October 25, 2023

Re: FortisBC Energy Inc. (FEI)

Application for a Certificate of Public Convenience and Necessity (CPCN) for the Okanagan Capacity Upgrade (OCU) Project (Application) ~ Project No. 1599152
Response to the British Columbia Utilities Commission (BCUC) Panel Information Request (IR) No. 2

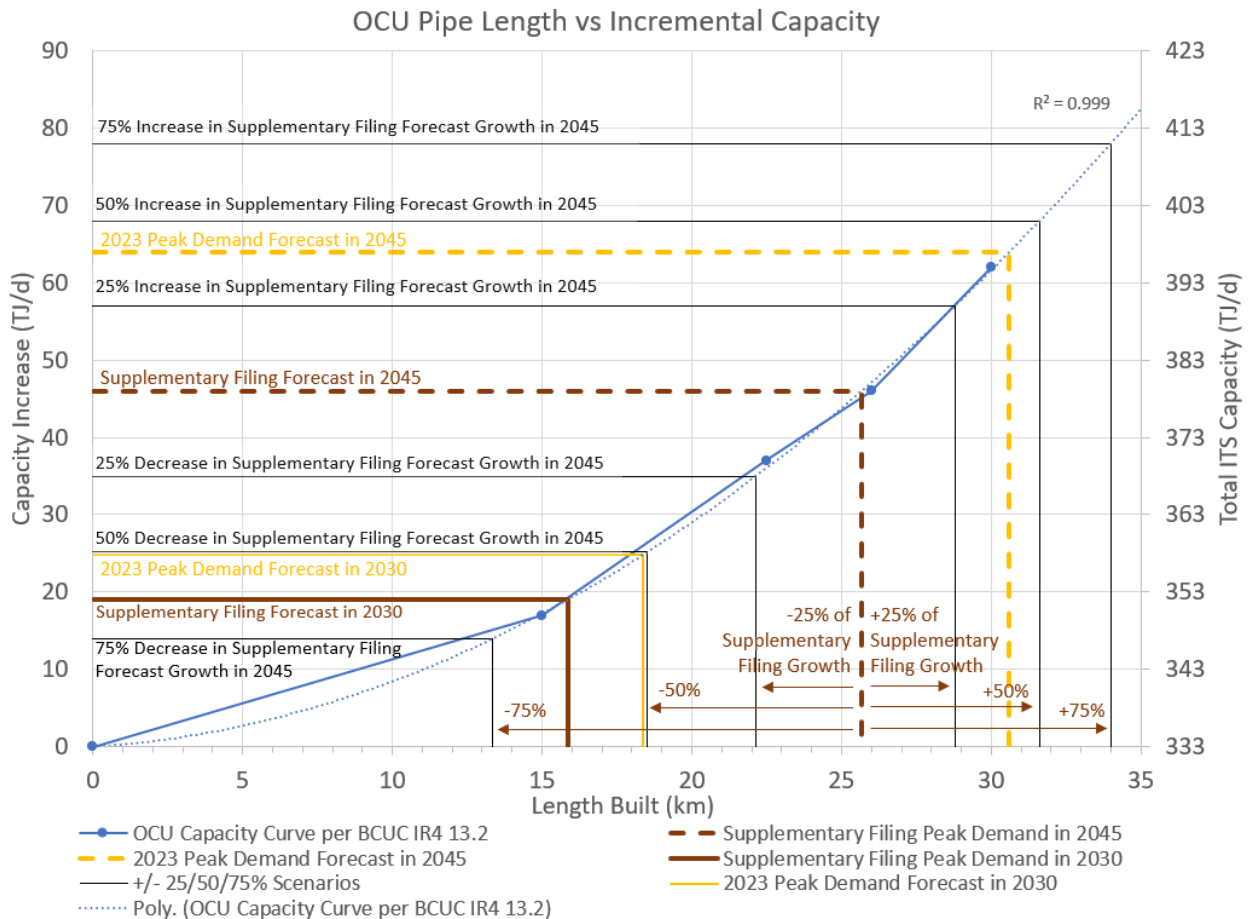
27 BCUC Panel IR2 3.3 asks that FEI consider alternatives, besides shortening the pipe, for
28 scenarios where the 20-year demand growth is up to 75 percent less than the Supplementary
29 Filing Forecast. However, to provide a more balanced scenario analysis, and in consideration that
30 both decreases and increases in potential future peak demand growth are plausible, the figure
31 below shows the pipe length required under scenarios where the Supplementary Filing Forecast's
32 20-year demand growth increases and decreases by 25, 50 and 75 percent.

1 Supplementary Filing Forecast). FEI has now completed its 2023 peak demand forecast as part
 2 of its annual planning cycle. Given the Panel’s questions regarding different peak demand
 3 forecast scenarios, FEI considered it appropriate to provide the now completed 2023 peak
 4 demand forecast as it represents the most up to date information available. The 2023 peak
 5 demand forecast was prepared using the same methodology as prior peak demand forecasts and
 6 shows a higher rate of growth than the Supplementary Filing Forecast due in large part to a higher
 7 growth in residential accounts supported by the most recent CBOC Housing Starts Forecast. By
 8 2045, the 2023 peak demand forecast suggests a demand requirement of 397 TJ/day and would
 9 require approximately 31 km of pipe to accommodate.

10 These scenarios are all shown in the figure below which relates the length of the Project to the
 11 capacity required. The figure was made using data provided in the response to BCUC
 12 Supplementary IR1 13.2. ITS capacity values were provided for scenarios where the OCU Project
 13 length was decreased by 4 km, 25 percent and 50 percent. Those data points are plotted as a
 14 function of pipeline length in the figure below. The capacity benefit relates to the length of pipe
 15 constructed by a second order trendline that can be used to approximate the required length for
 16 a given capacity requirement.

1 The above figure not only confirms that the OCU Project is needed, but it also illustrates the
2 diminishing value realized by decreasing pipe length as the change in capacity is proportional to
3 the square of the change in length. That is, reducing the pipe length by 50 percent reduces the
4 capacity benefit by approximately 75 percent.
